TOWN OF BAY HARBOR ISLANDS PLANNING AND ZONING BOARD

November 7, 2018

FINAL AGENDA

Subject: Single-Family Residence – Demo Existing Home / New Construction
1270 98th Street
Bay Harbor Islands Acct. No.: MB2017-65
MMPA Acct. No.: 01-0702-1073

1 SITE PLAN
1/8" = 1'-0"

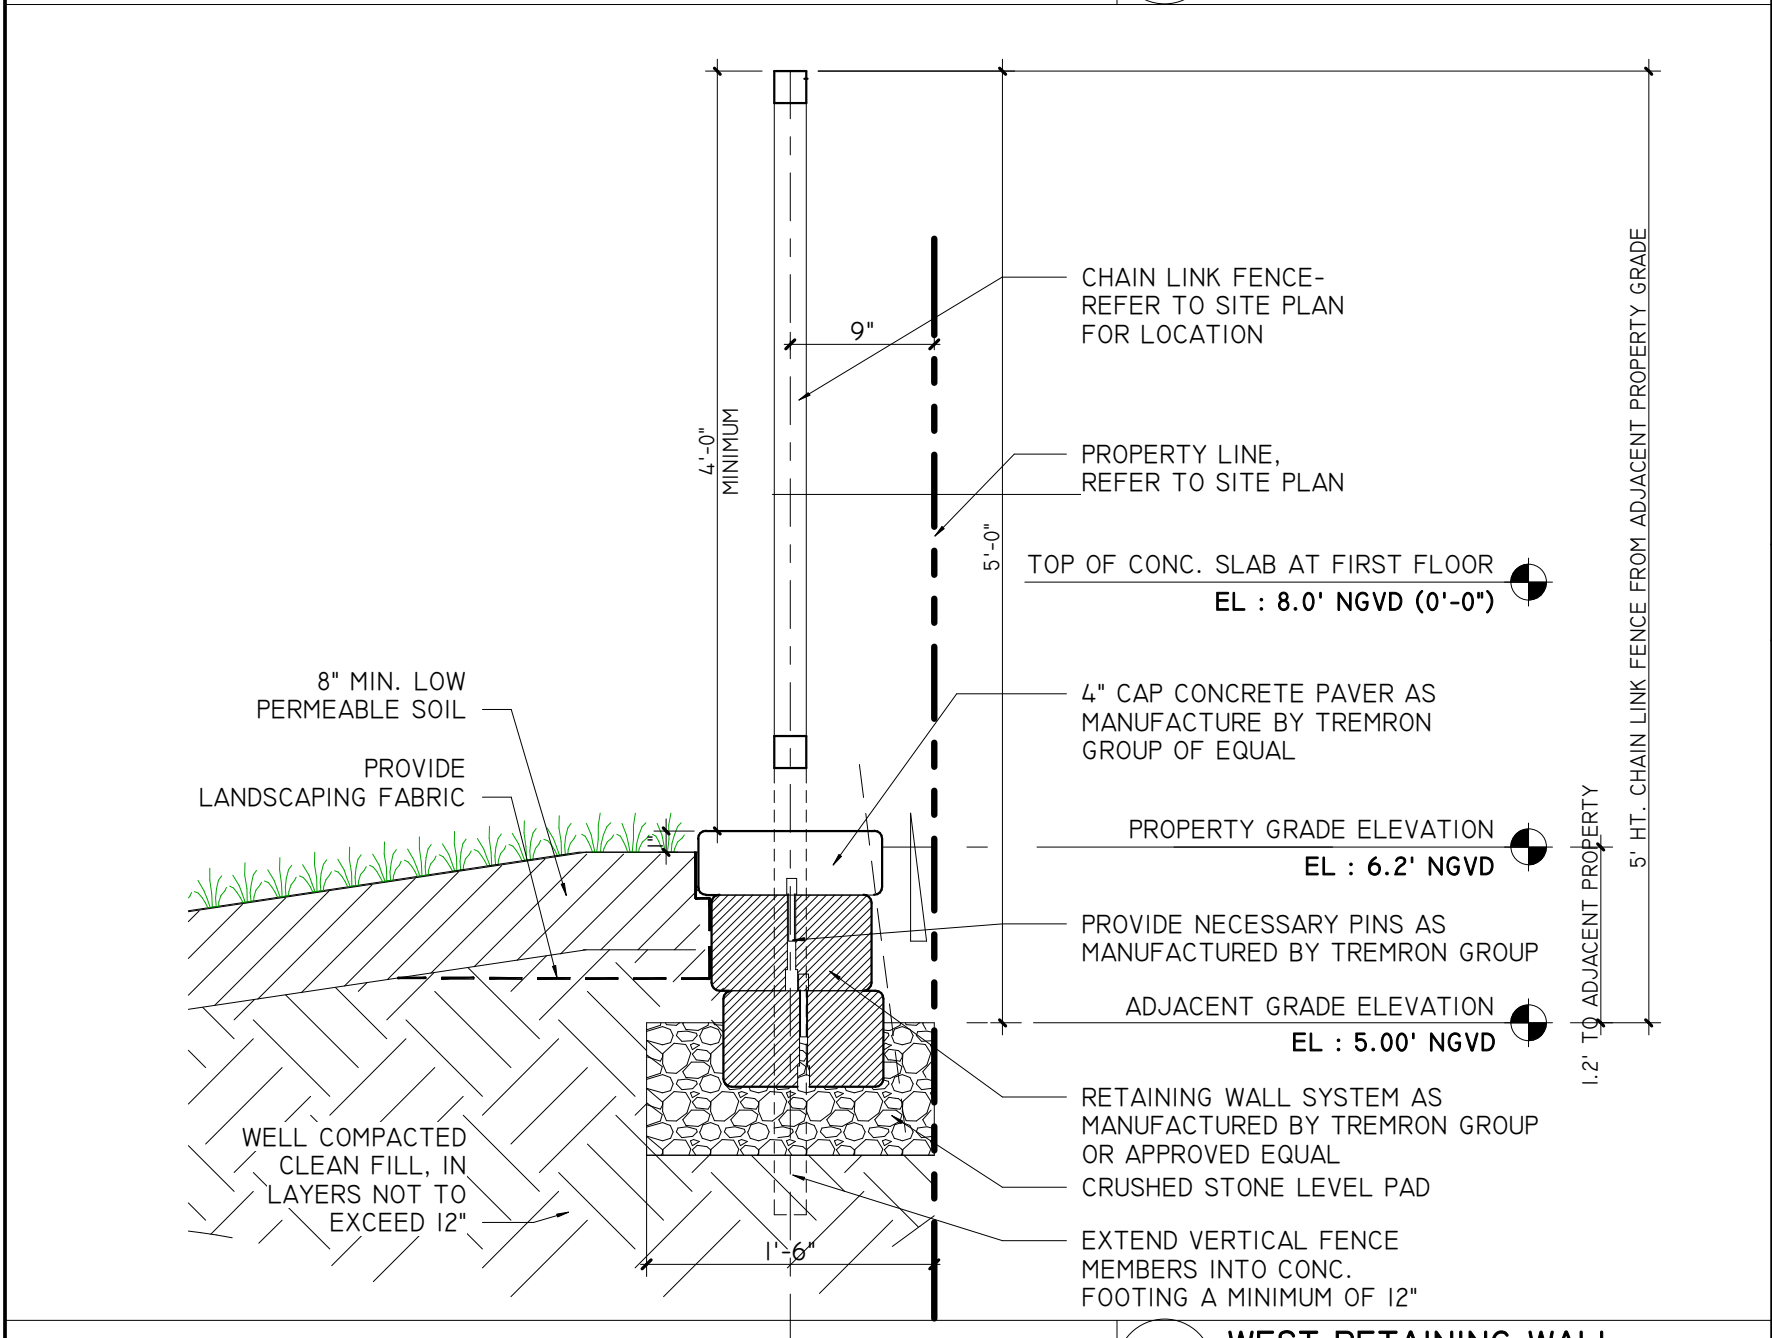
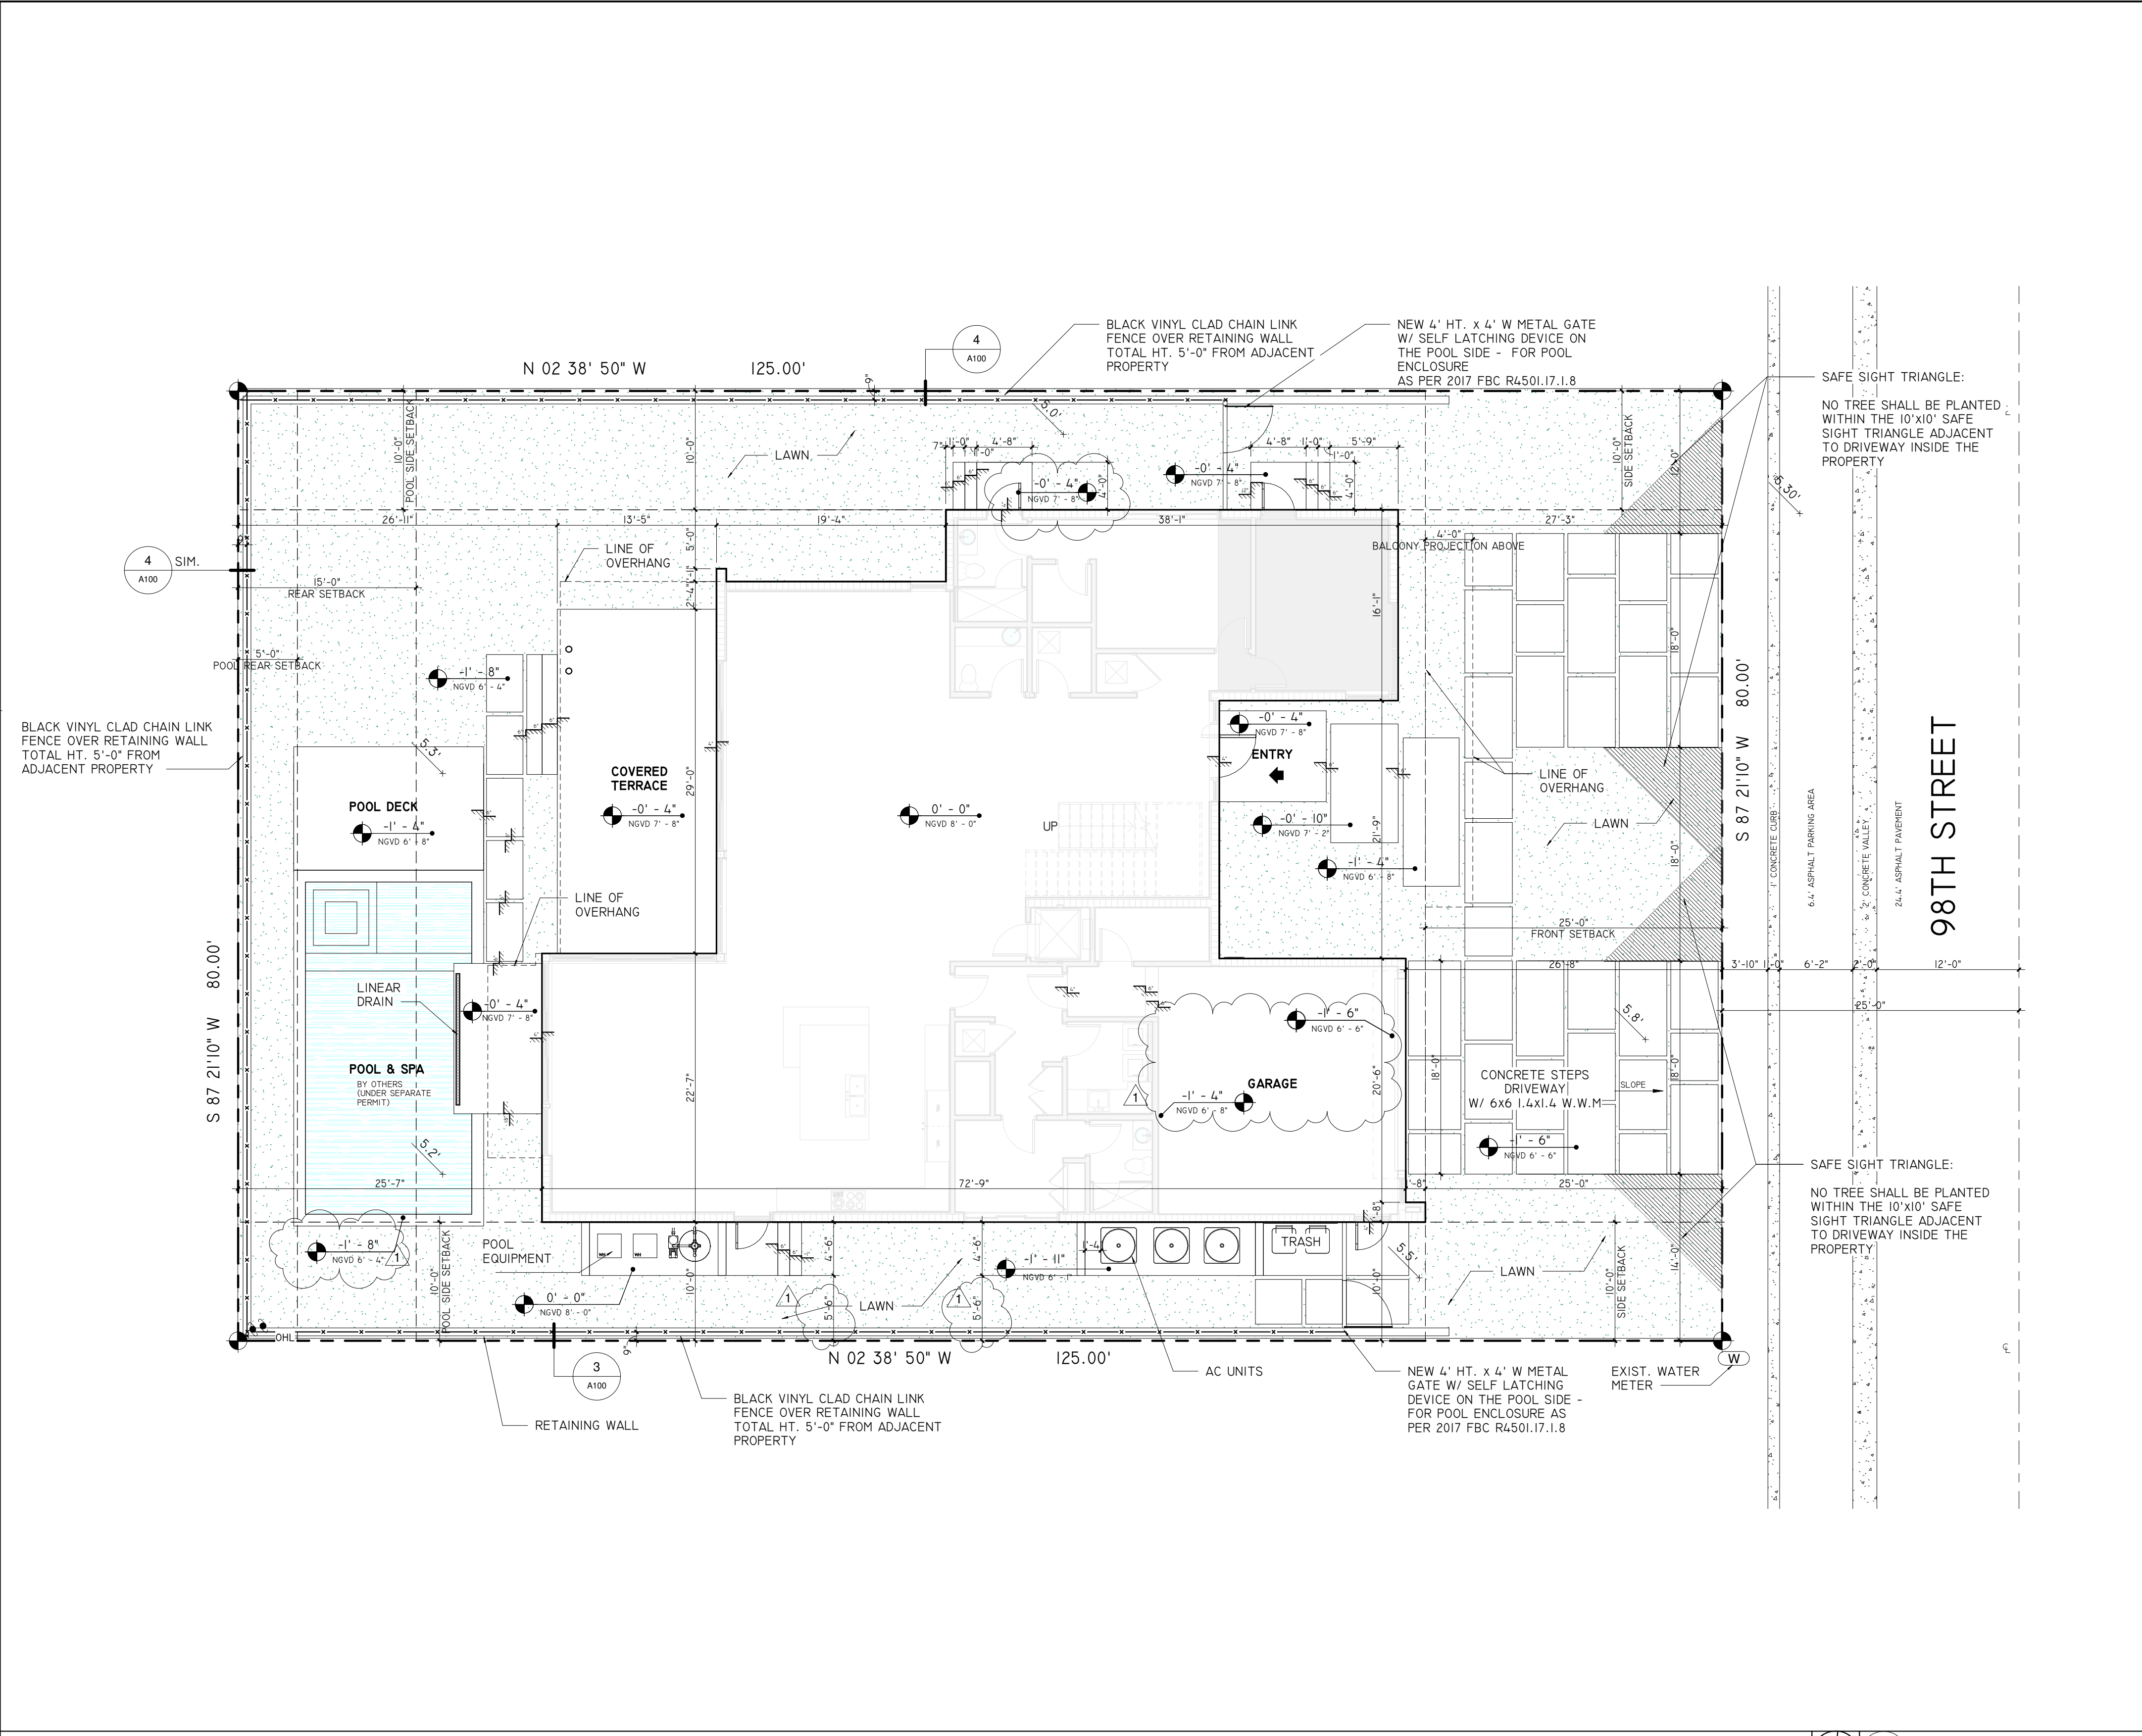
- 1) This approval is based on the plans prepared by SDH Studio dated October 2nd, 2018 with any modifications required by the PZ Board. Any future modifications to the above plans shall be reviewed by Town staff / MMPA and may require re-approval by the PZB if felt to be substantial.
- 2) The PZB must approve the uneven side yard grades / side yard retaining wall design as per Town Code §23-12(12).
